## **PLANNING AND DEVELOPMENT SERVICES STAFF REPORT**

**For Planning Commission Meeting of August 5, 2025**

**SUBJECT: The Crescent (2525 Ann Arbor-Saline Road) Site Plan and Rezoning for City Council Approval  
File No. SP24-0006**

*Figure 2 Proposed Layout*

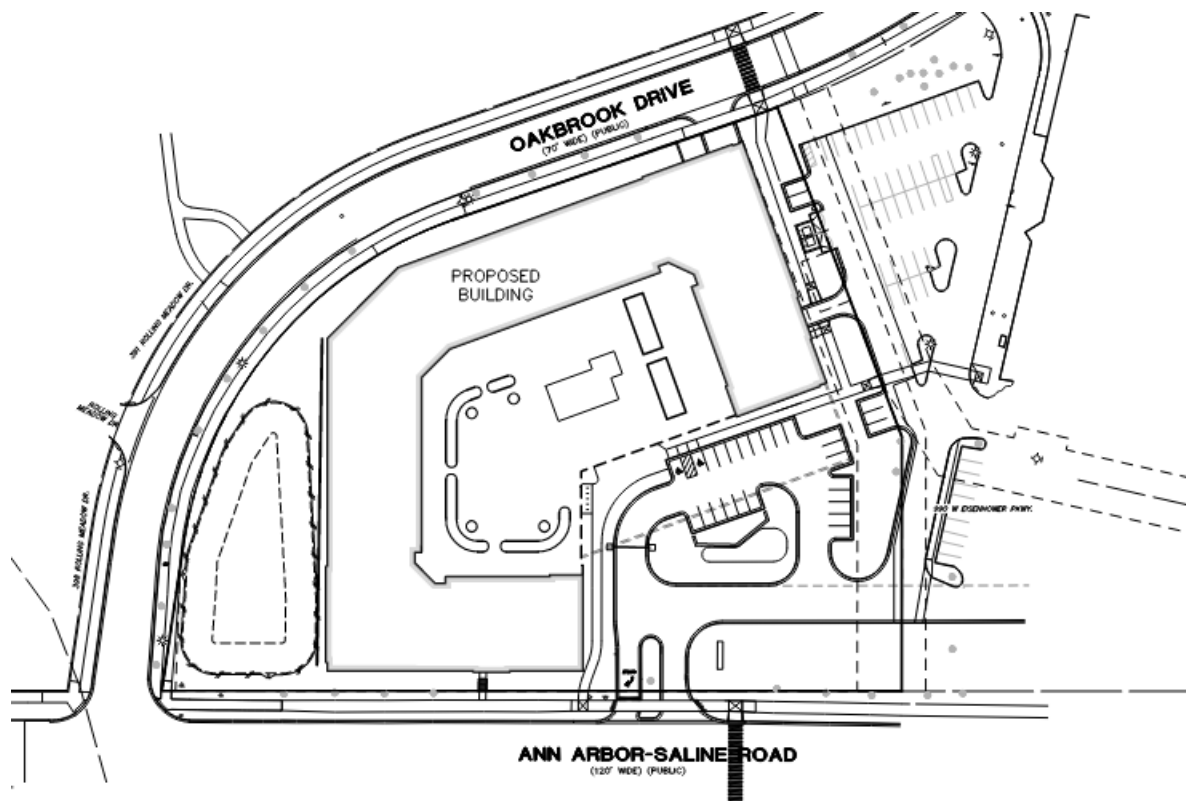
Parks and Recreation – The petitioner has agreed to a crosswalk across Oakbrook Drive that connects to Cranbrook Park at the request of the Parks and Recreation Department.

Transportation – Transportation staff has agreed to work with the petitioner to determine the final location of the proposed crosswalk on Ann Arbor-Saline Road during the civil plan review process.
